PLANNING APPLICATION NUMBER:P08/0173

Type of approval sought	Full Planning Permission
Ward	GORNAL
Applicant	Mr & Mrs Reynolds
Location:	18, MANOR DRIVE, LOWER GORNAL, DUDLEY, DY3 2XQ
Proposal	TWO STOREY SIDE EXTENSION TO CREATE STUDY AND UTILITY WITH BEDROOM AND ENLARGED BATHROOM ABOVE.
Recommendation Summary:	APPROVE SUBJECT TO CONDITIONS

proposed side elevation

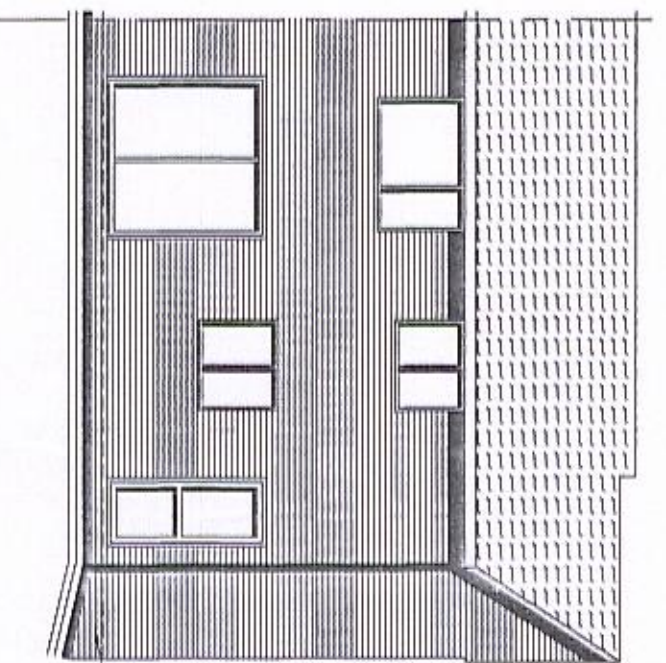
11. The application indicates a side facing landing window in the first floor elevation. The adjacent neighbour has requested that this fixed and obscure glazed. This window would be angled towards No 16 Manor Drive and, as it would be inserted into a wall along the side boundary, it would overhang the neighbours' airspace if opened. It is considered reasonable therefore to place a condition on any approval that this window shall be fixed and obscure glazed.

12. The neighbour is also concerned about the insertion of a side facing door in the garage. Given the change in levels this does have the potential to overlook the adjacent front garden. However, consideration must be given to the fact that the applicant could place a door in the side elevation of the garage and change its use using permitted development rights. It would seem therefore that the best way to reduce the impact of the door is to place a condition on any approval requiring the installation of a 2.0m high boundary fence in the vicinity of the doorway to prevent overlooking.

1. The development hereby permitted shall be begun before the expiration of three years from the date of this permission.
2. The window to be installed in the first floor side elevation of the extension shall be fitted with obscure glass and be fixed, having no opening lights. This shall be maintained for the life of the development.
3. Notwithstanding the provisions of the General Permitted Development Order 1995, no other openings except those indicated on the approved plan shall be formed in

4. Prior to the occupation of the extension a 2.0m high close boarded boundary fence shall be erected along the line indicated on the approved plan and thereafter maintained for the life of the development.
5. Prior to the occupation of the extension a hard standing capable of accommodating two cars shall be created to the front of the dwelling within the application site. This shall be maintained for the life of the development.
6. The materials used in the external elevations of the development hereby approved shall match in type, texture and colour those of the existing building unless otherwise agreed in writing by the Local Planning Authority.
